SUBJECT: Forwards response to NRC 800223 request re LWR primary coolant sys pressure isolation valves. No mods to OL necessary.

DUKE POWER COMPANY
OCONEE NUCLEAR STATION

Response to Request for Information
NRC Letter Dated February 23, 1980

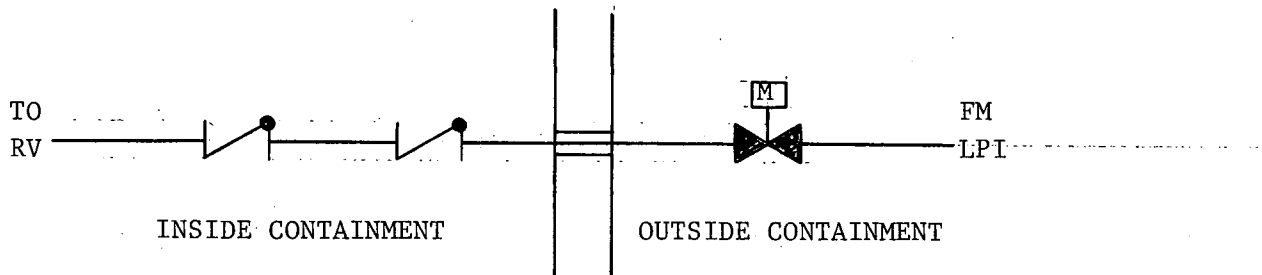
Describe the valve configuration at your plant and indicate if an Event V isolation valve configuration exists within the Class I boundary of the high pressure piping connecting PCS piping to low pressure system piping; e.g., (1) two check valves in series, or (2) two check valves in series with a MOV.

The piping configuration at Oconee which most closely approximates Figure 1 is as follows:

The MOV is normally closed except during quarterly testing and upon unit shut-down when the system is in use for decay heat removal.

The above Event V configurations as contained in Figure 1 do not exist at Oconee. However, during quarterly testing of the MOV, the valve is cycled and system lineup of Figure 1 would exist. The MOV is never locked open.

The above Event V configurations as contained in Figure 1, do not exist at Oconee. However, during quarterly periodic testing, the MOV in question is cycled. To prevent the possibility of over pressurizing the low pressure piping, Duke is modifying the inservice testing program to require this MOV to be tested during periods of cold shutdown.
